Appendix A

Notice of Preparation
and Public Comments

**Notice of Preparation and Notice of Scoping Meeting
for an Environmental Impact Report**

Subject: Notice of Preparation of an Environmental Impact Report for the Aramis Solar Energy Generation and Storage Project, County Planning Application PLN2017-00174

Figure 1. Density of location points of an adult golden eagle outfitted with satellite transmitter #59490. Note overlap of density points with the Project’s footprint, as roughly highlighted in the yellow ring. Unpublished data, EBRPD.

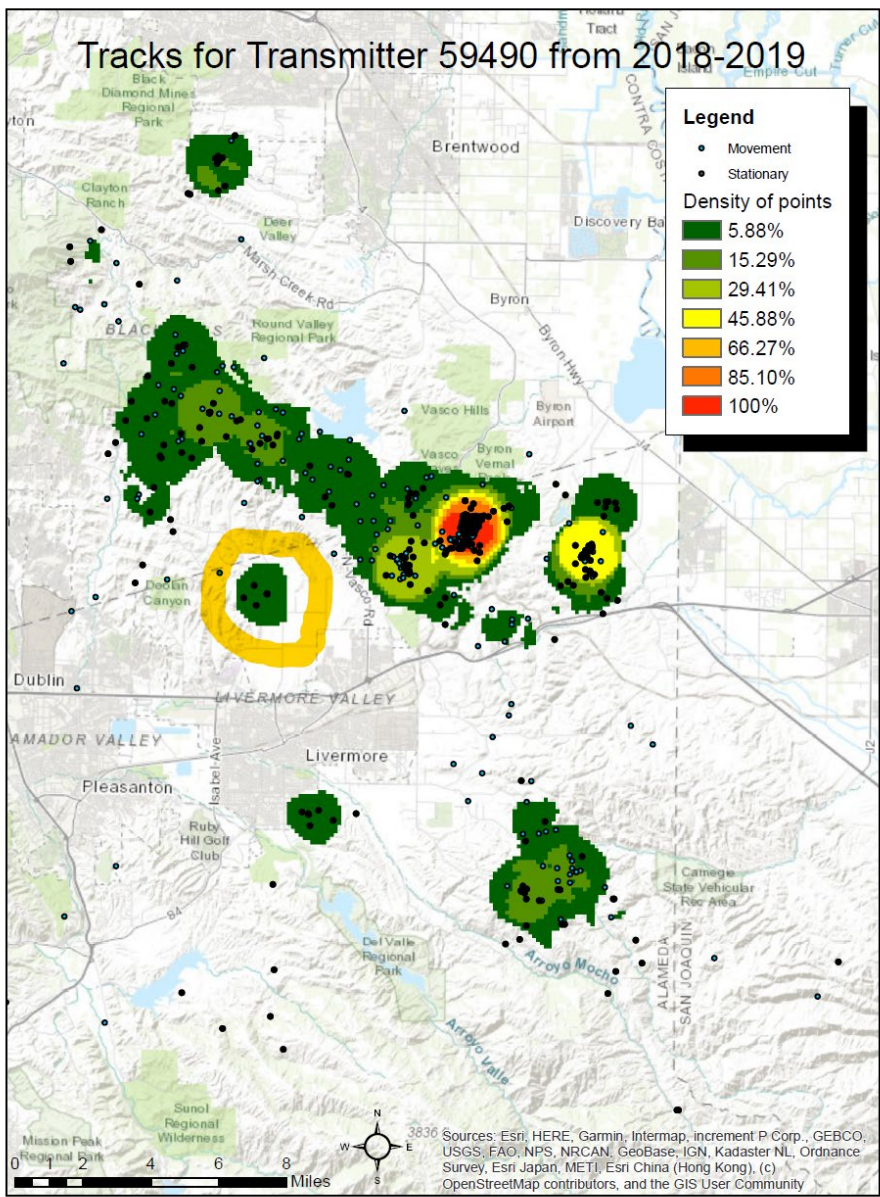
3. Given direct impacts to volant animals, the EIR should include an avian and bat fatality monitoring plan to assess volant animal mortality resulting from interaction with the Project's infrastructure, similar to fatality studies that have been developed for wind projects in the Altamont Pass Wind Resource Area (APWRA) and that are reviewed by the County's Technical Advisory Committee.
